## **ATTACHMENT J**

### **Comments from Other Stakeholders**

- ACCCE Comments on BenMAP study
- Comments on Draft MANE-VU Reasonable Progress Goals Document - Dominion
- Comments on Draft MANE-VU Reasonable Progress Goals Document - MOG
- Comments on Draft MANE-VU Reasonable Progress Goals Document - UARG
- Reliant Energy Comments on MANE-VU report
- Modeling for Reasonable Progress Draft Report Stakeholder Comments
- UARG Comments on MANE-VU 2018 Modeling

**Figure ES-3. Changes in annual mean PM<sub>2.5</sub> with EGU1 with IPM candidate control program.**

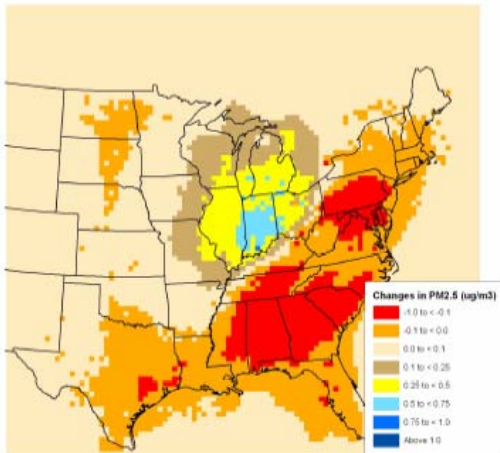
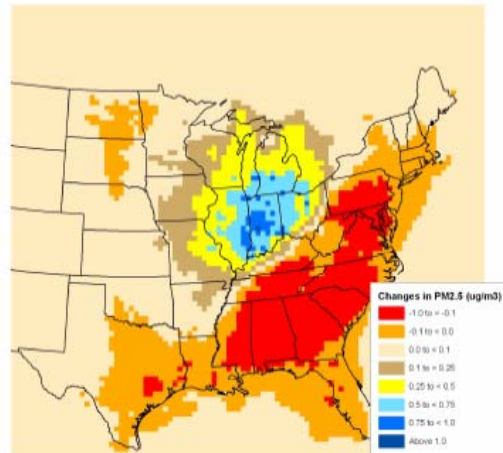
ACCCE does not agree with the methodology or assumptions underlying the BenMAP analysis, for reasons discussed in comments previously submitted to the Midwest RPO by Cambridge Environmental,<sup>3</sup> and attached here. We note that similar analyses of "CAIR-Plus" strategies evaluated for MRPO by Stratus Consulting in 2006 also presented alternative modeling results based on unrestricted emission trading.

Stratus' findings for MRPO, summarized in the IPM cases modeled below, indicate that the potential downwind impacts of emissions "leakage" from the MRPO region largely offset the benefits of controls imposed within the MRPO. When unrestricted emission trading is permitted, the emission reductions resulting from CAIR-Plus controls within the MRPO region generate tradable allowances that can be sold outside the region. The Stratus analysis illustrates the effects of such trading in states outside the MPRO region, based on IPM modeling of annual PM<sub>2.5</sub> concentrations:

**Figure 1 Composition Plot of Regional Haze at Lye Brook Wilderness Area, 2005**

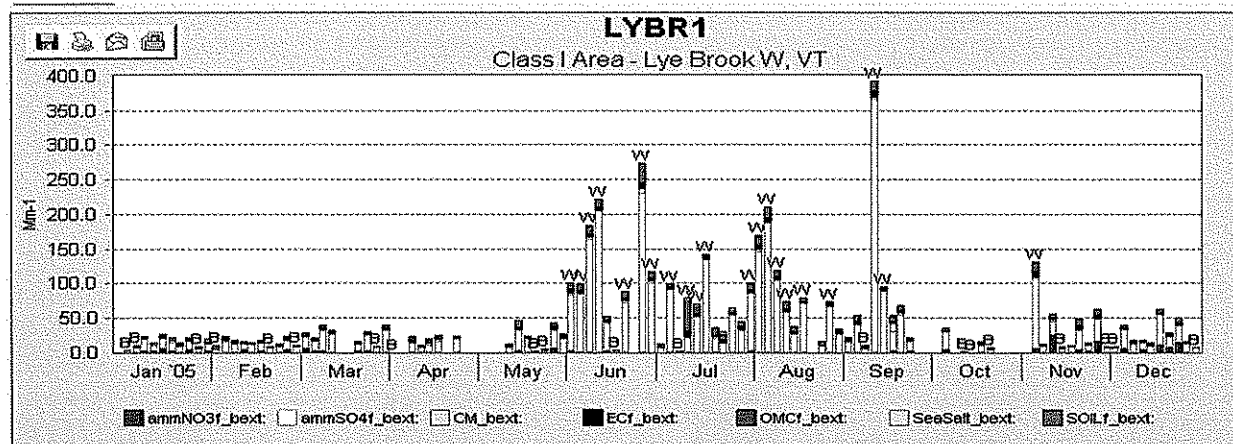
*Comment #1 on Section 2: Poor modeled meteorological performance during the summer period has significant implications for conclusions regarding source attribution for regional haze impacts.*

The meteorological evaluation indicates that the MM5 performance is poorest during summer conditions (June-August), which is a period that corresponds to many of the worst-case regional haze days (as noted from a review of the IMPROVE data from the web site at <http://vista.cira.colostate.edu/views/>). Therefore, attribution of targeted emission sources that may contribute to the worst 20% days (many of which occur in summer; for example, see Figure 1) is uncertain due to the poor modeled meteorological performance (particularly with regards to the trajectory analysis). It should also be noted that the modeled meteorological performance was poorest for the southern U.S. and interior portions of the U.S. East Coast (NESCAUM states) as compared with other areas included in the model domain. This may have consequences for the accuracy of the efficacy of the BOTW regulations that are advocated by the NESCAUM report.

**Figure 2 PM<sub>2.5</sub> Sulfate Performance Plot from Draft MANE-VU Report**

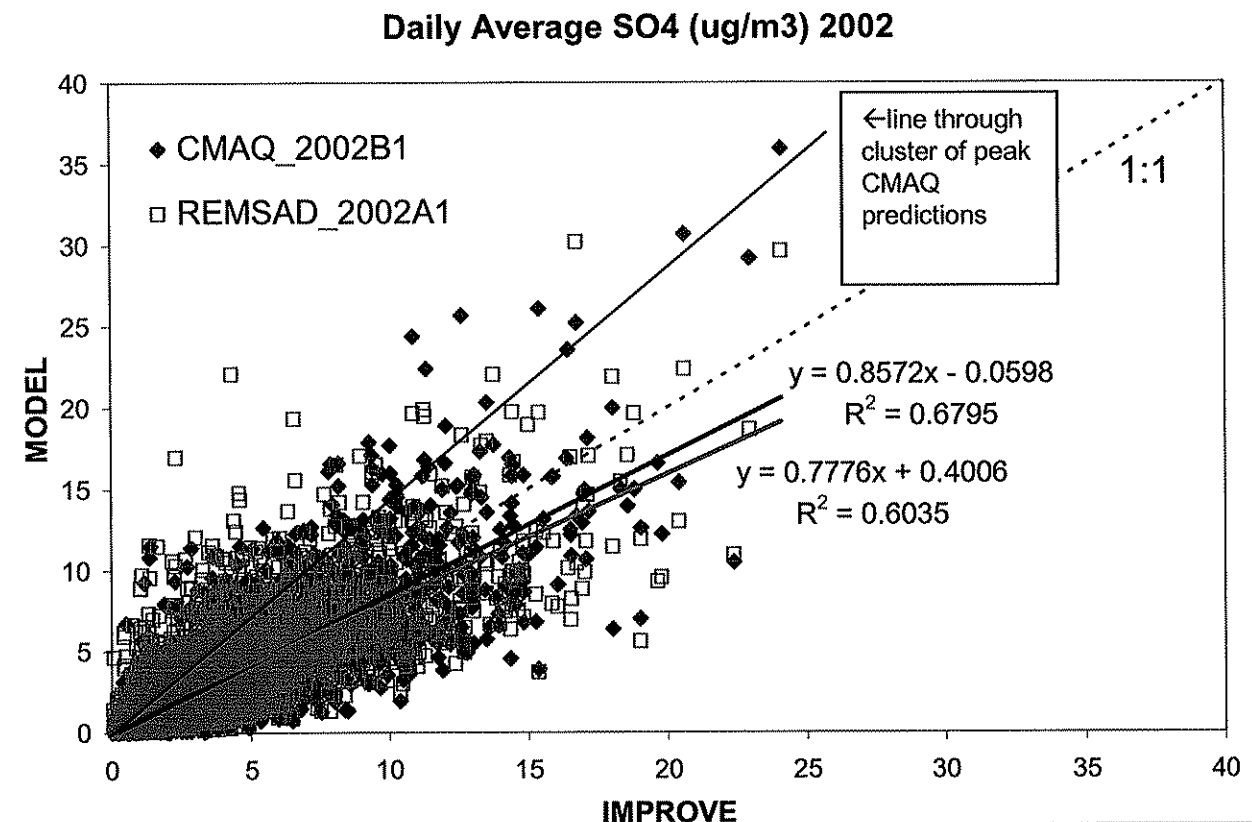
*Comment #3 on Section 2: The regression lines and slopes attributed to the model performance plots do not match the peak prediction areas in some cases.*

Some of the figures presented in the report (components of Figure 2-11 and Figure 2-16) have best fit lines drawn in the figures that do not appear to match the line one would eyeball that would pass through the peak values. Since the peak values are most important in determining the trend of the worst 20% regional haze days, it makes sense to reconsider the best-fit lines for this purpose. For example, Figure 2 shows the sulfate particulate predictions vs. observations from the report’s Figure 2-11. The blue best fit line far from the area of peak predictions, which are better matched by an alternative line added to Figure 2.

**Figure 3 PM<sub>2.5</sub> Elemental Carbon Performance Plot from Draft MANE-VU Report**

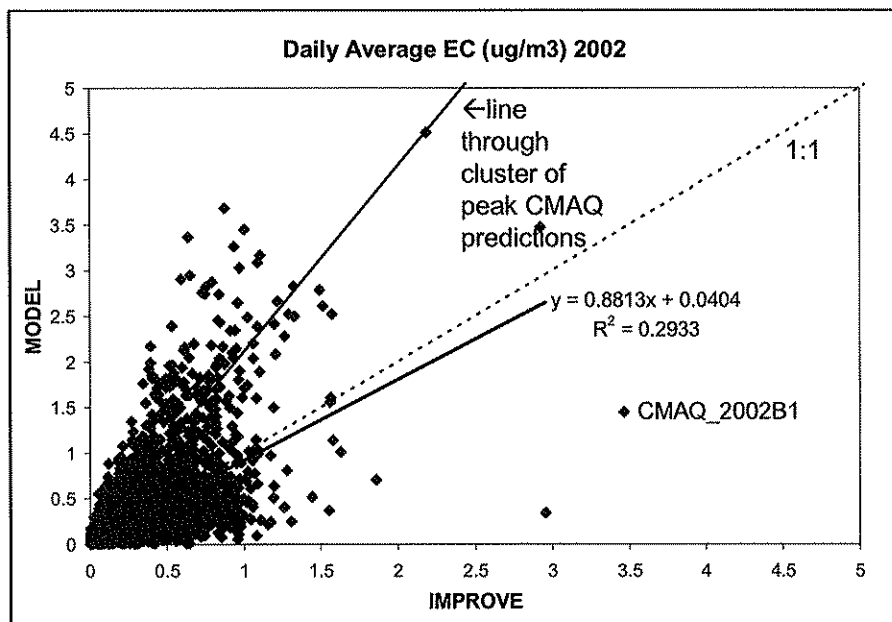
Similar eyeballed best-fit lines through the peak CMAQ predictions are added to Figures 3 and 4. These alternative slopes lead to conclusions that the CMAQ model's peak predictions are too high (i.e., the model is over-responding, especially on the worst 20% regional haze days), and can result in a conclusion that certain emission components have an exaggerated effect on visibility.
